Development Review Division

TO: Casey Adragna, Adragna Architecture
FROM: Elizabeth Steward, Associate Planner- Development Review
DATE: 10/27/25
SUBJECT: Douglas 234 Multitenant, Site Plan
Review Comments 02

SITE PLAN
HORSE CREEK COMMERCIAL
 LOT 10B, DOUGLAS 234 FILING NO. 6, AMENDMENT 2
 A PORTION OF THE SW 1/4, SE 1/4, SECTION 29, T6S, R66W, 6TH P.M.
 TOWN OF PARKER, COUNTY OF DOUGLAS, STATE OF COLORADO

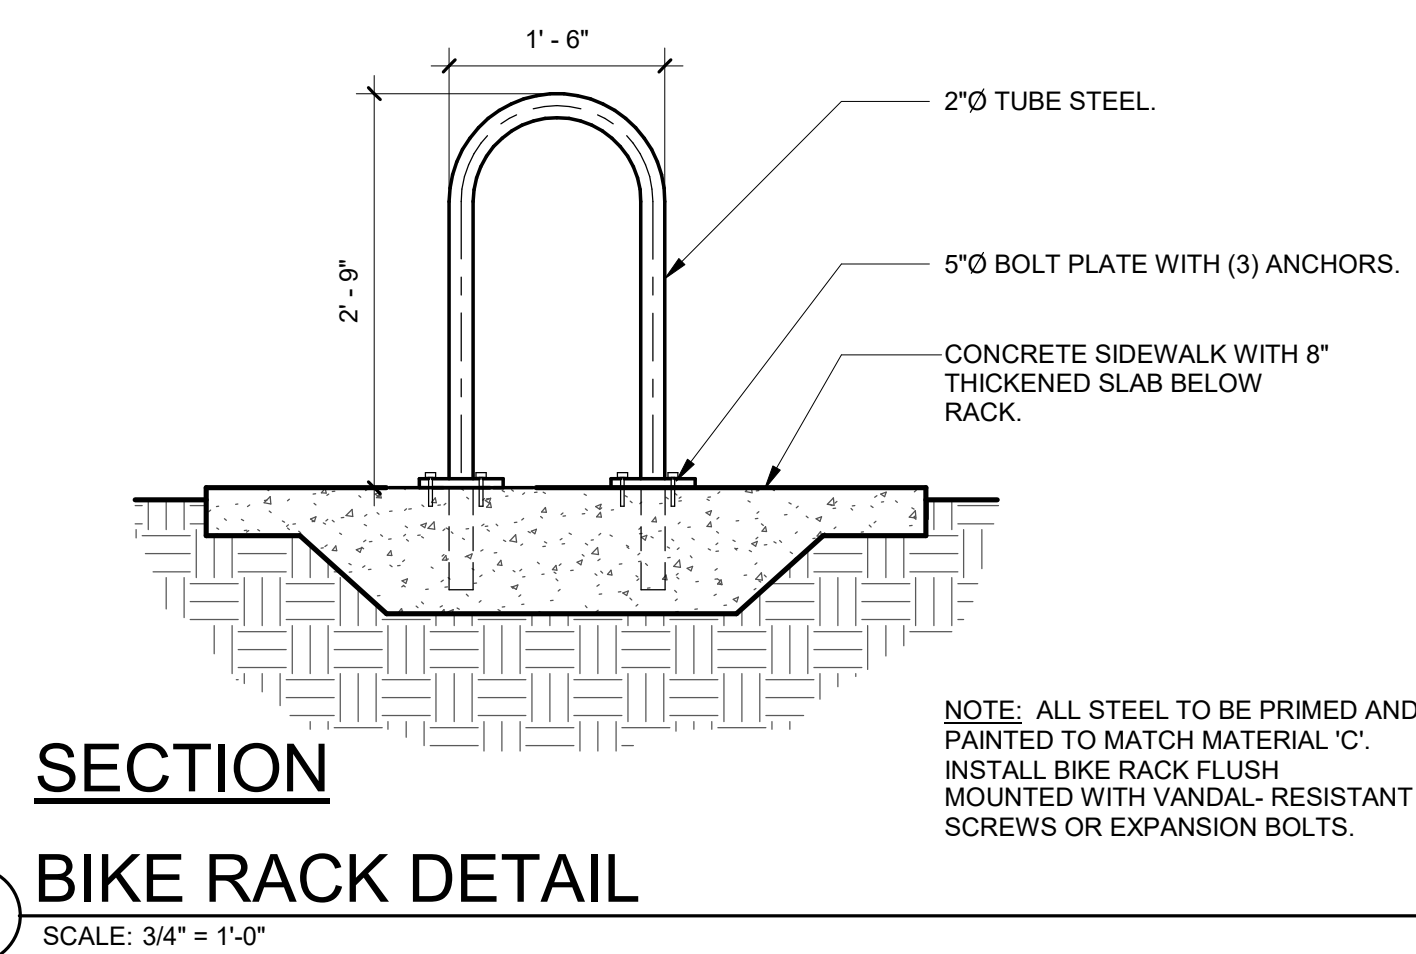
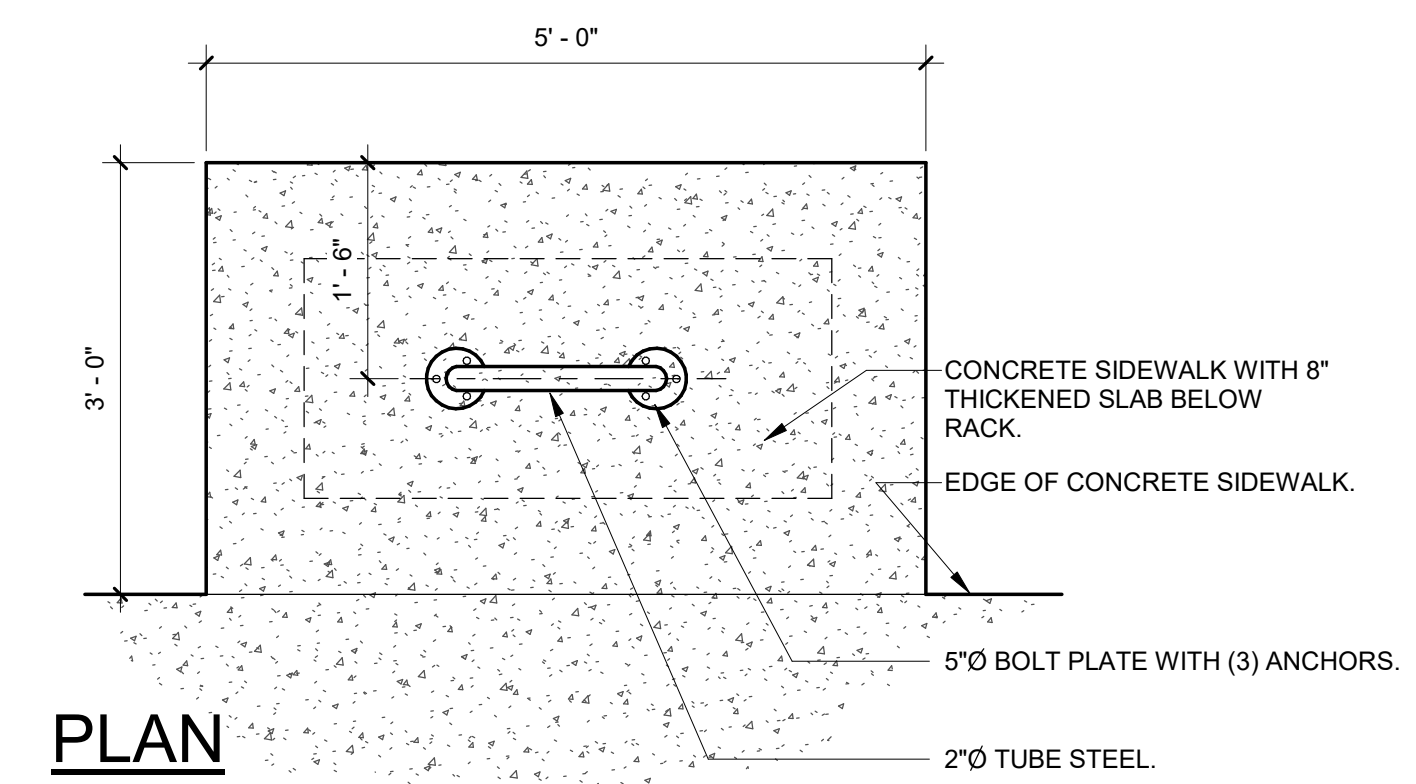
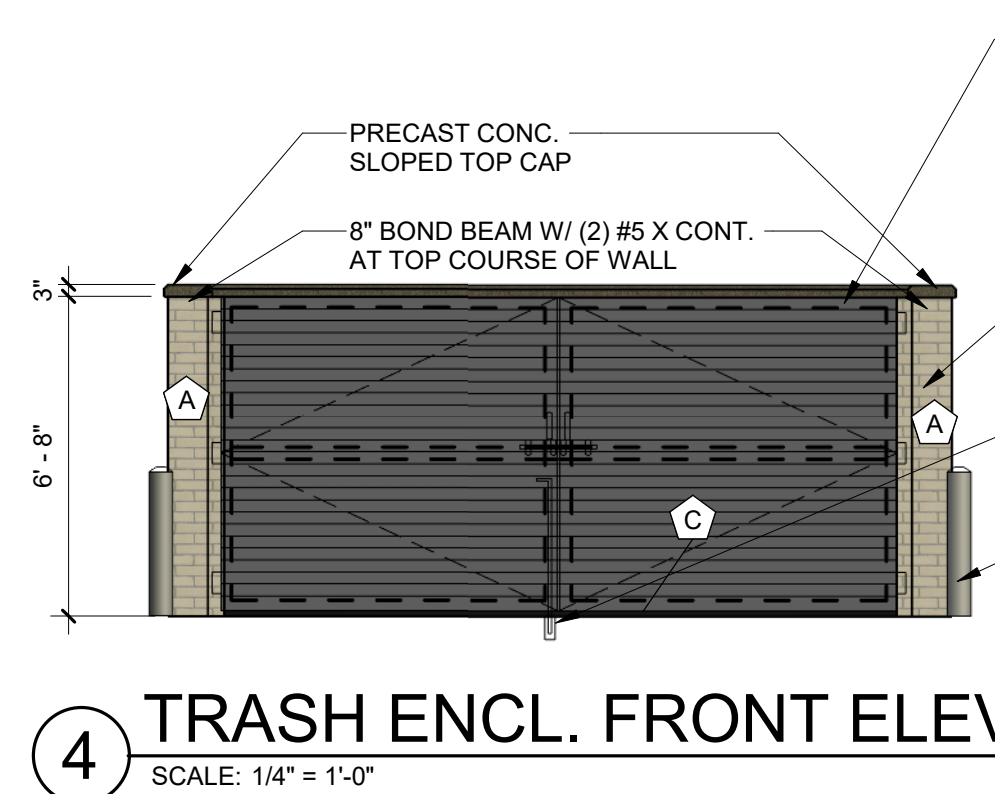
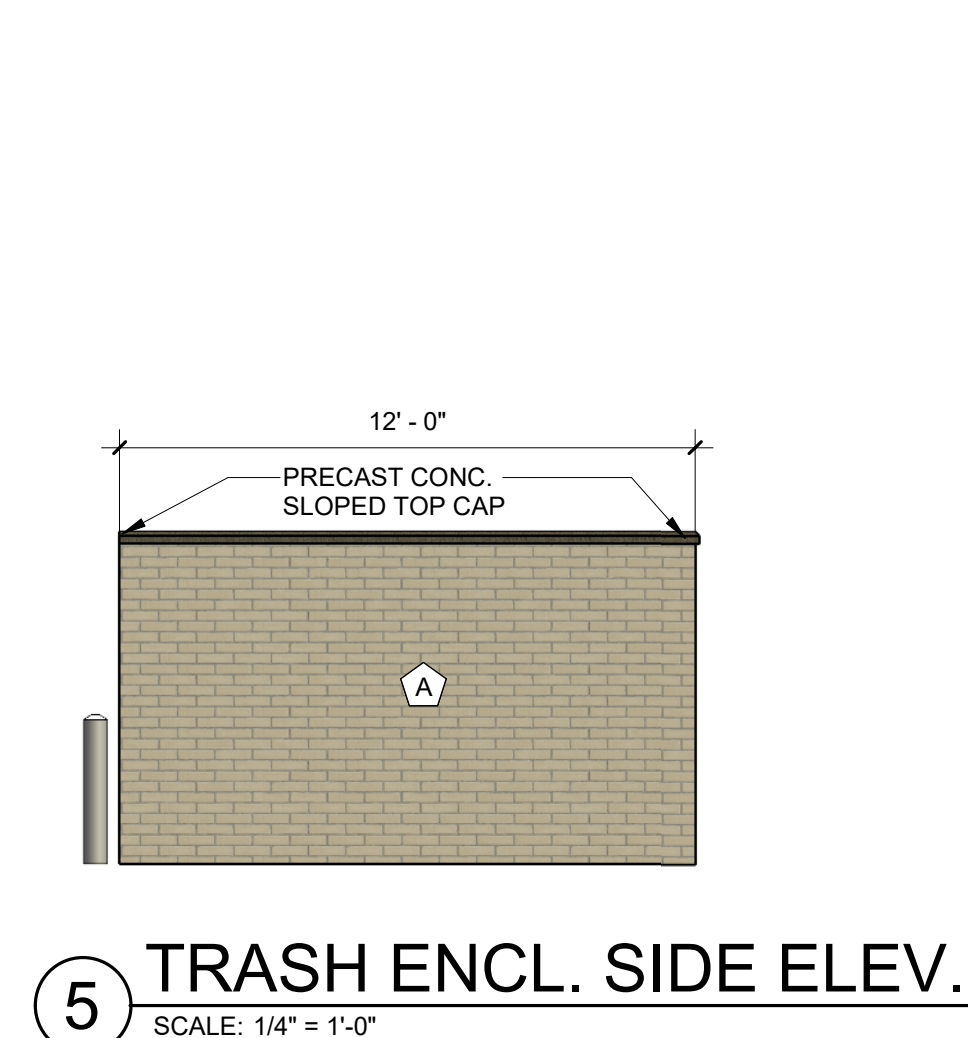
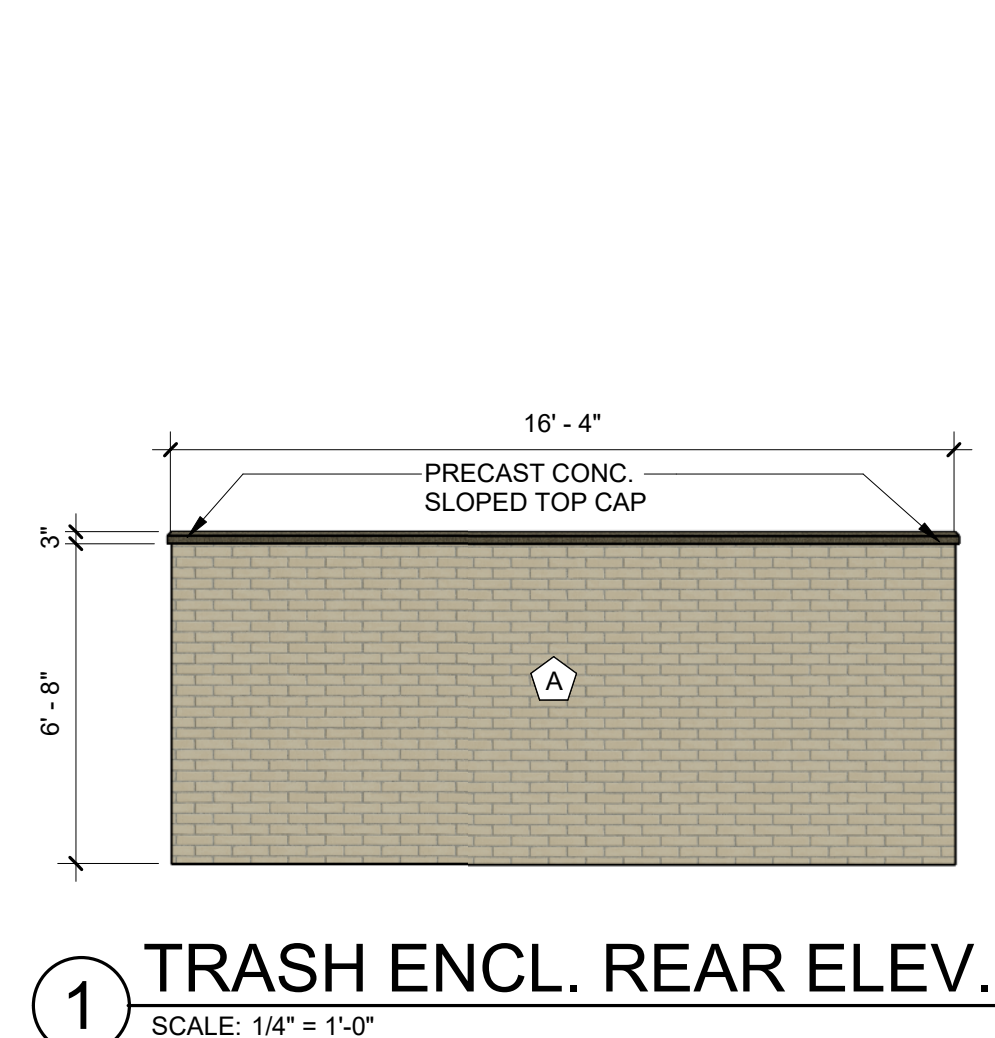
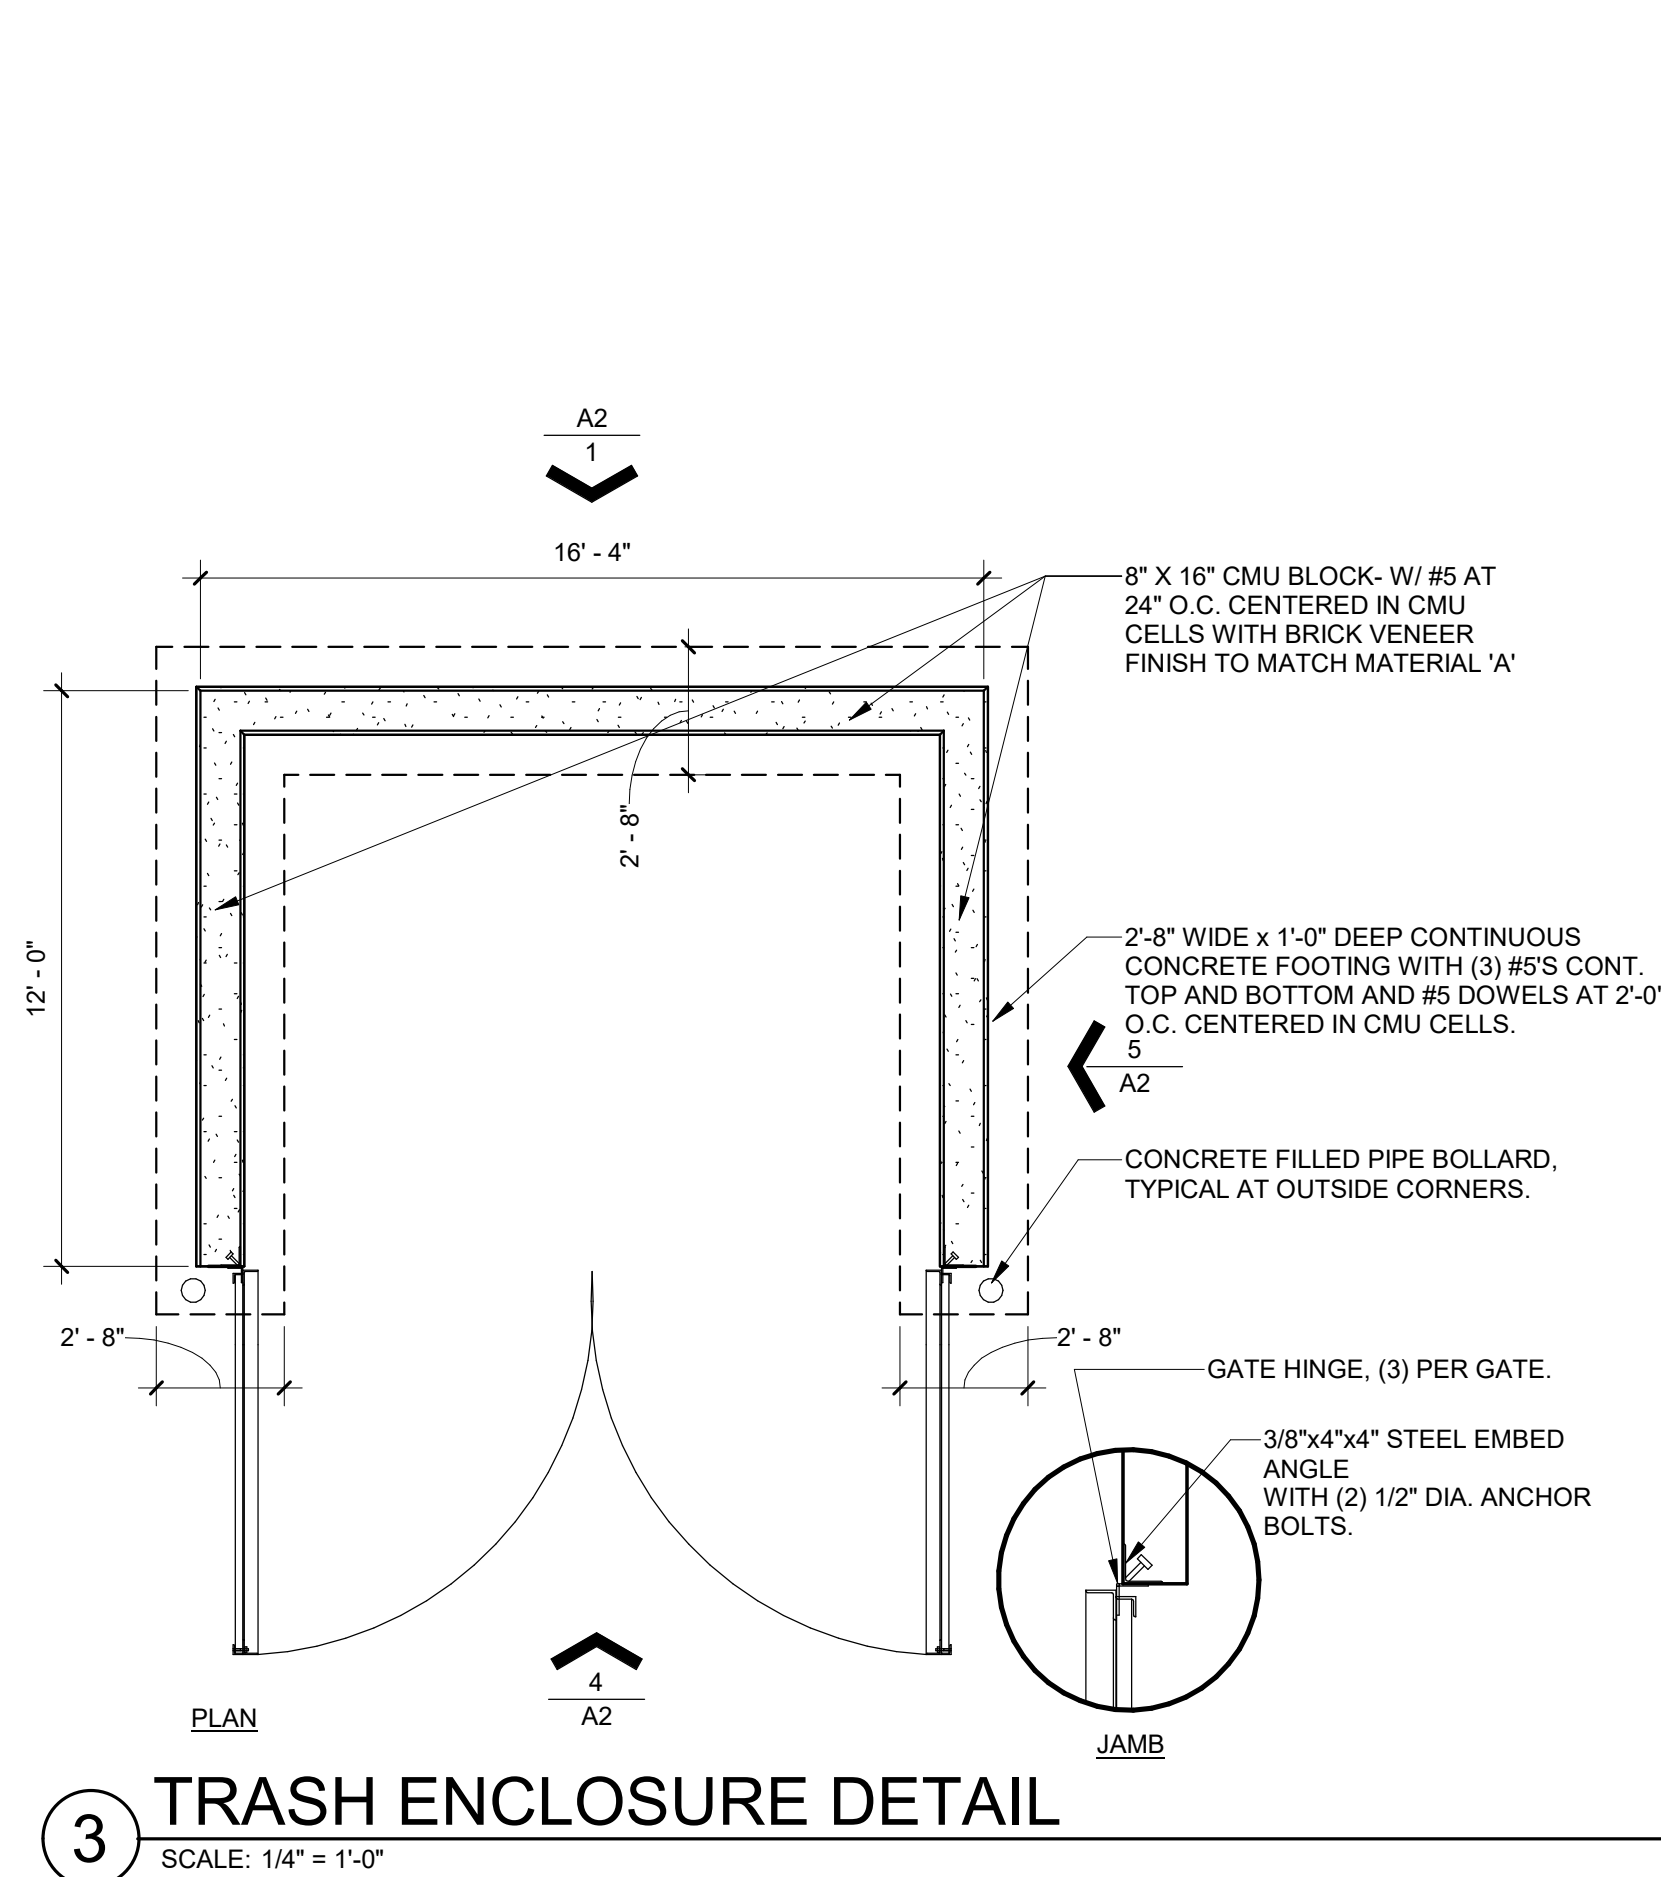
Spec needed for railings- color and material
